**OIL INDIA LIMITED**  
**(A Government of India Enterprise)**  
**P.O. Duliajan – 786602, Assam, India**  
**Website: [www.oil-india.com](http://www.oil-india.com)**

**Corrigendum No. 1 to IFB No. CPG8895P19**

**Engineering, Fabrication and supply of Modular Packages Contract (MPC) for OCS at Nadua and GGS at East Khagorijan in Dibrugarh District, Assam**

DRAWING NO.: 17039-EK-P-DW-0203-12 REV: B SHEET : 2 OF 2 SCALE : NTS

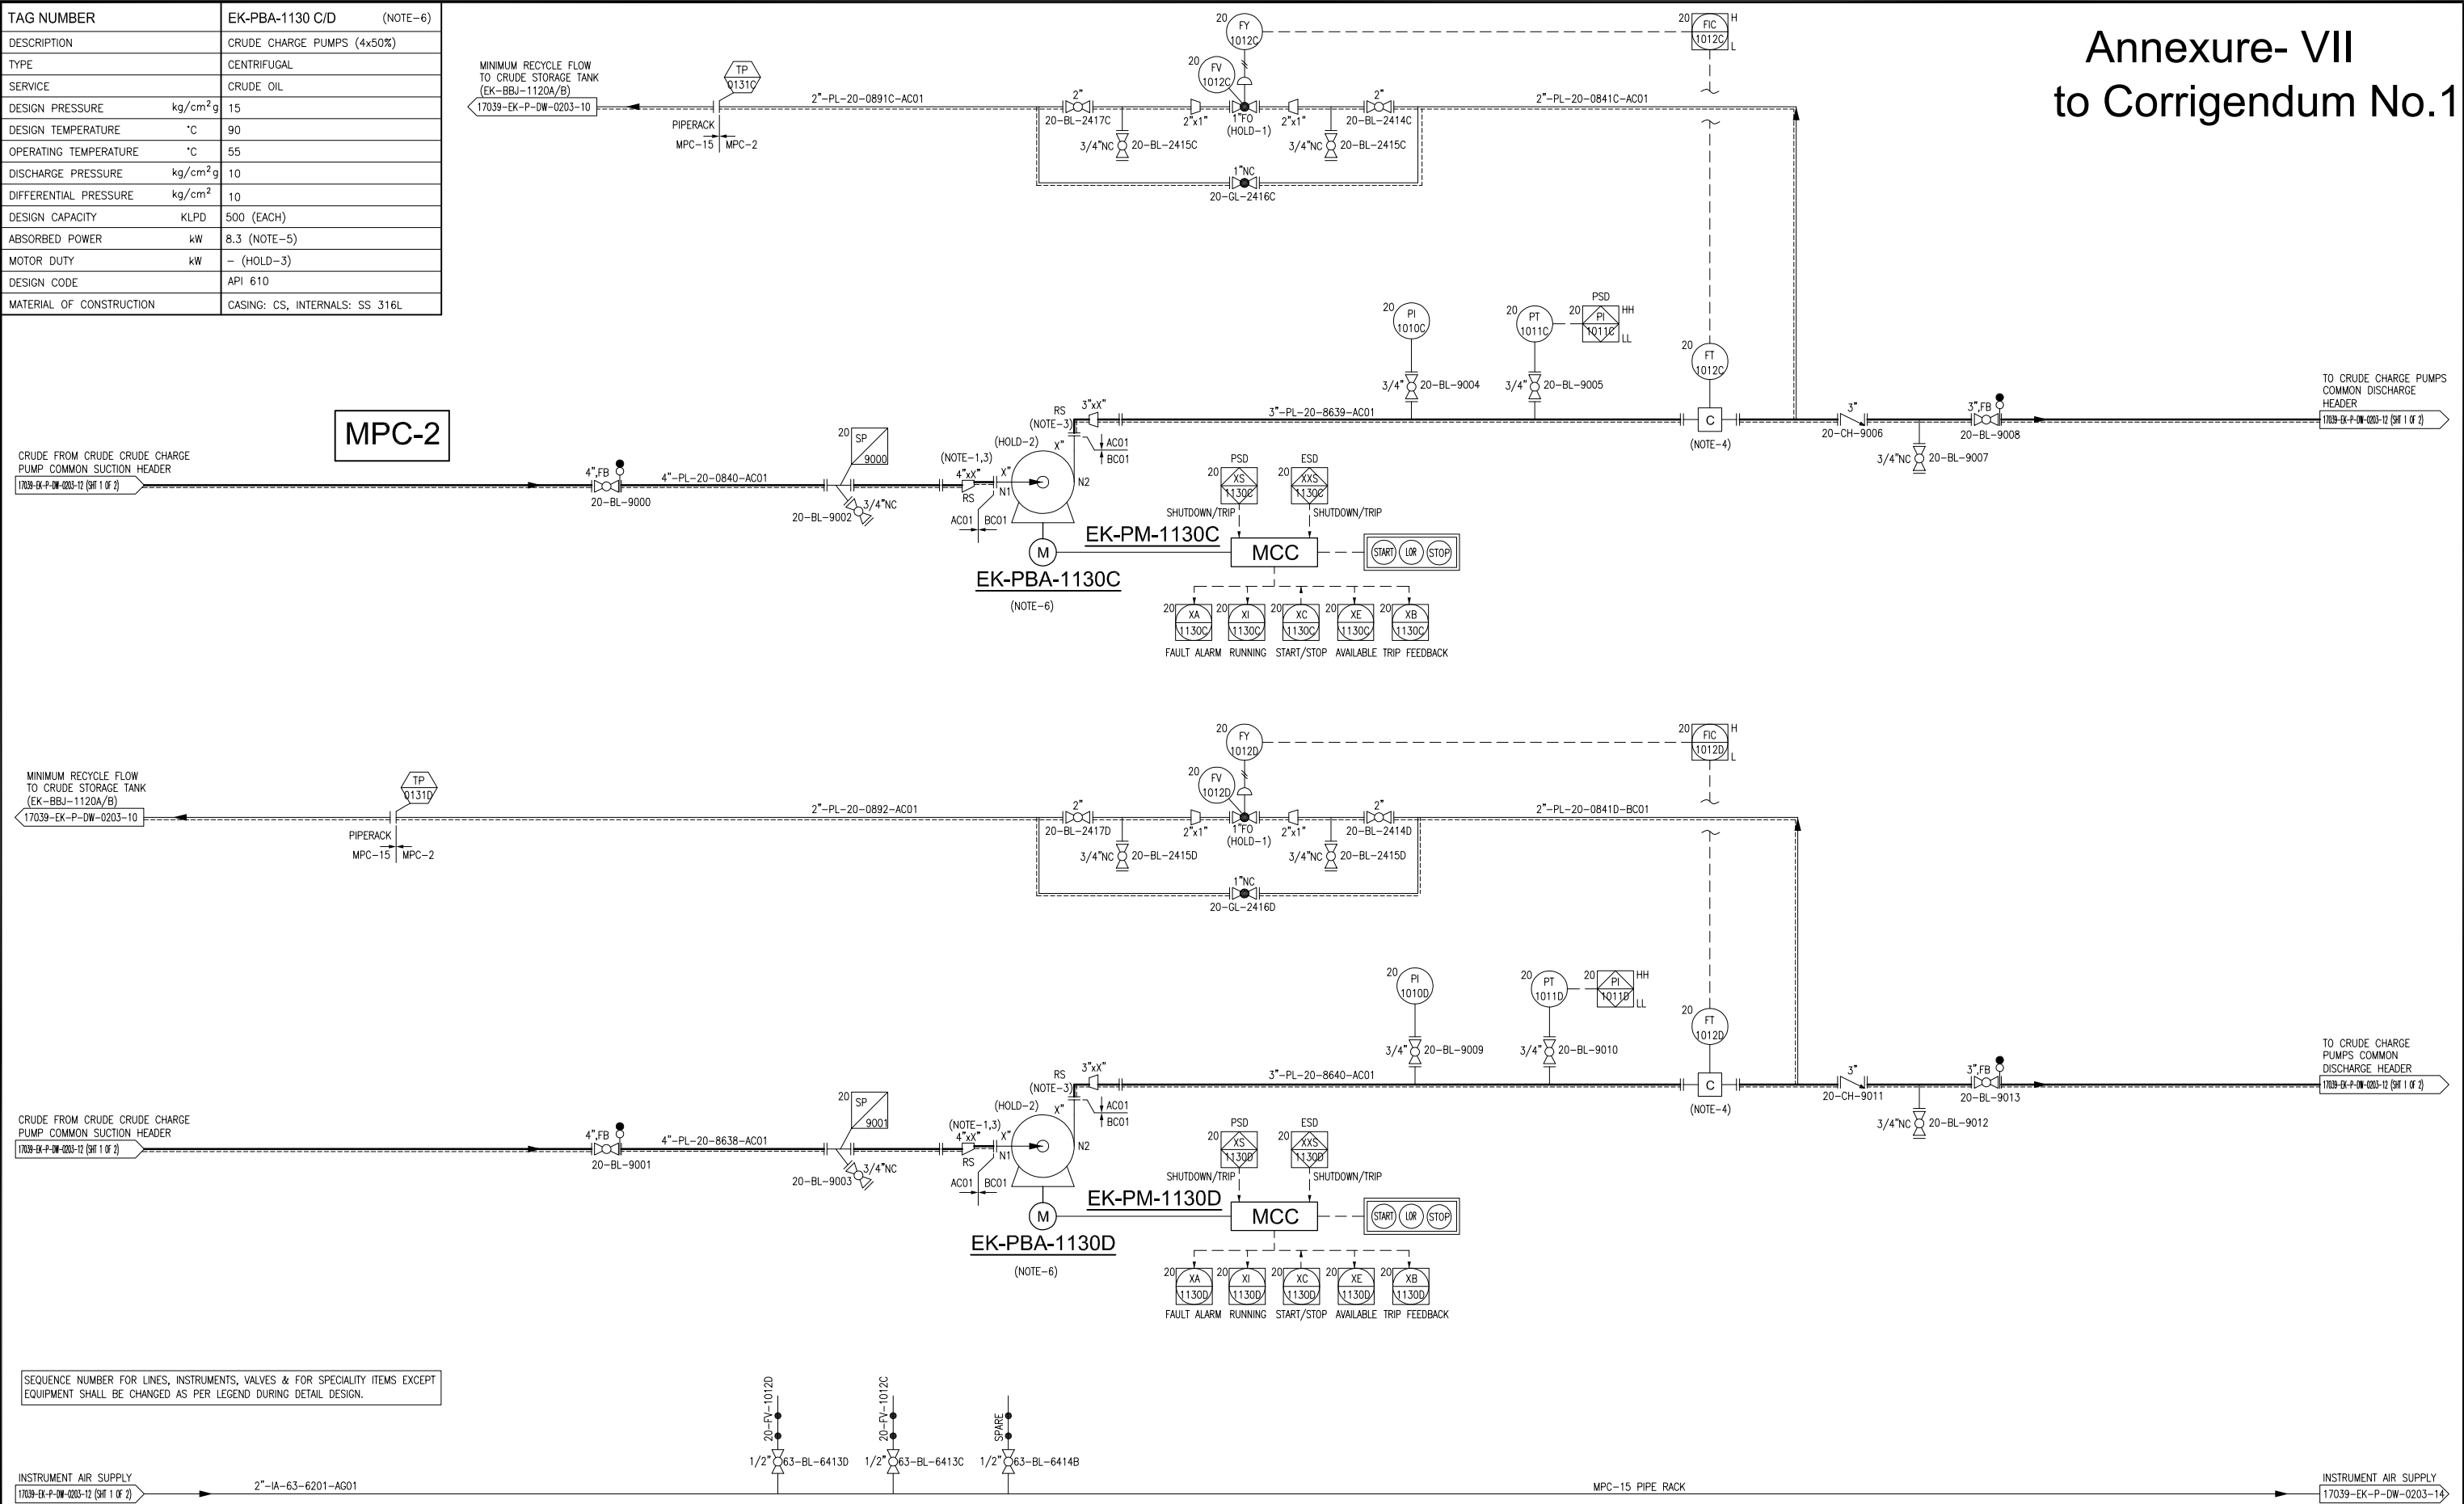
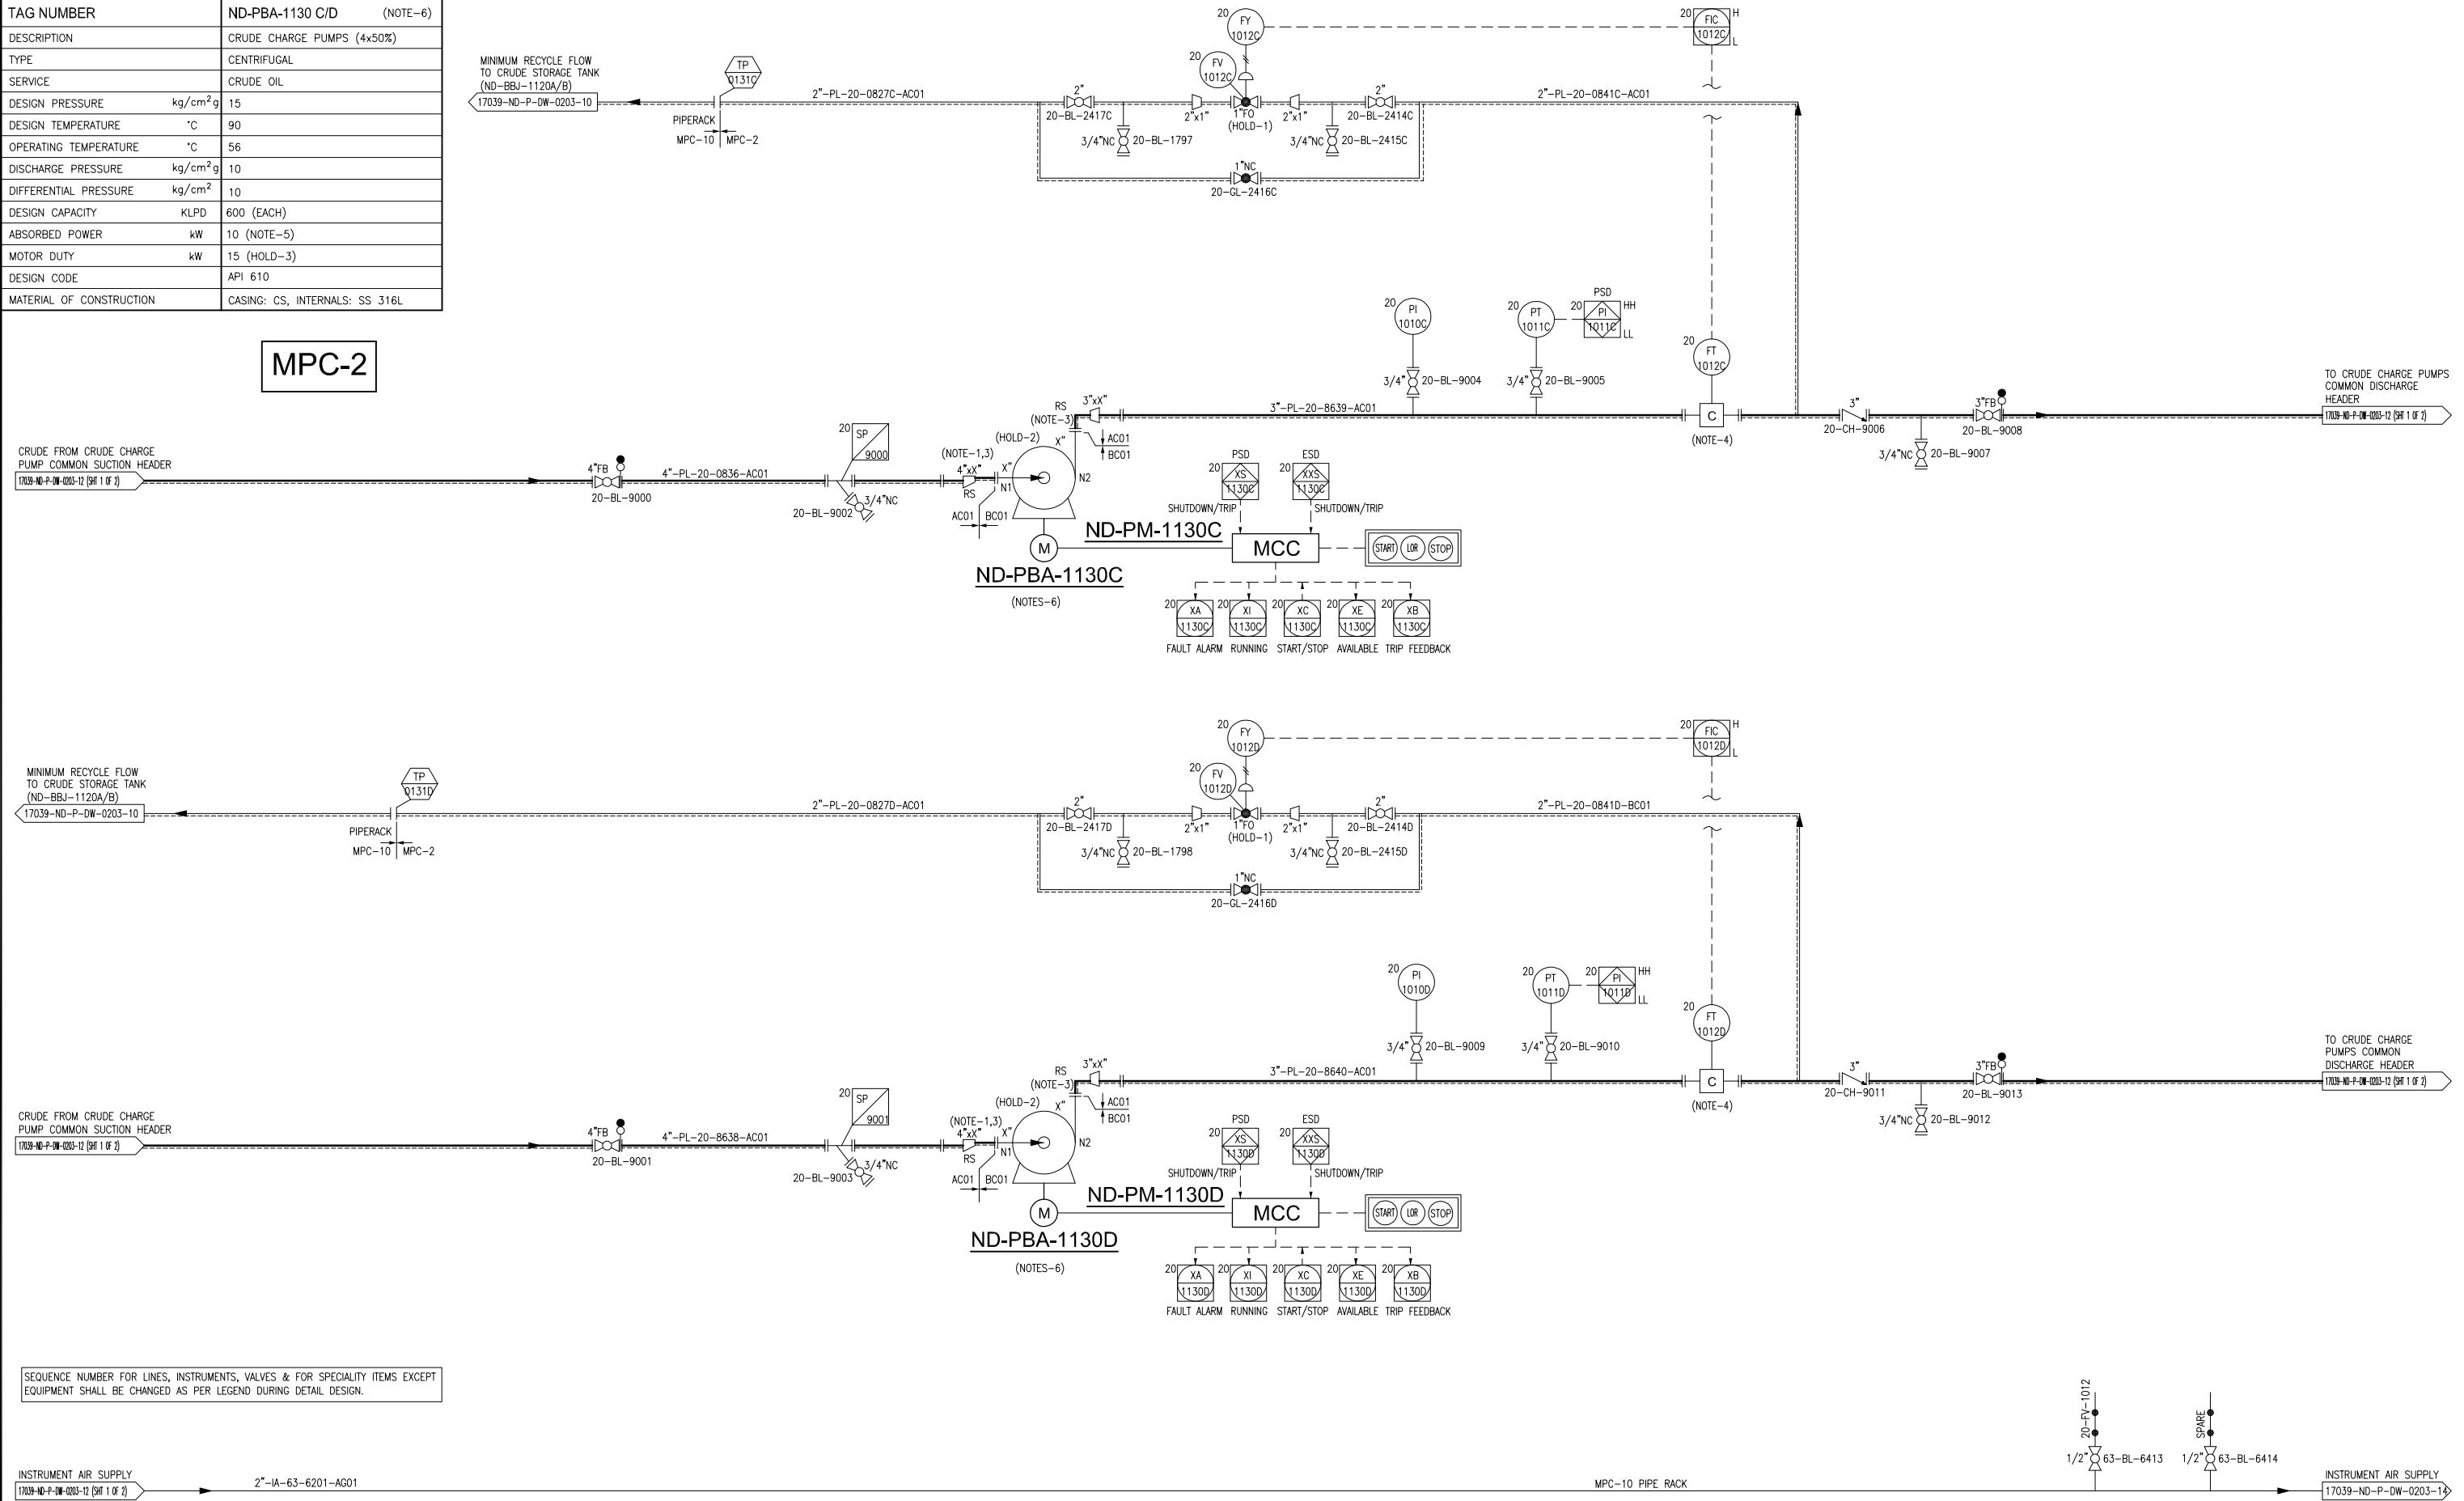
g) Revised P&ID for Crude Charge Pumps is attached as **Annexure- VII**.
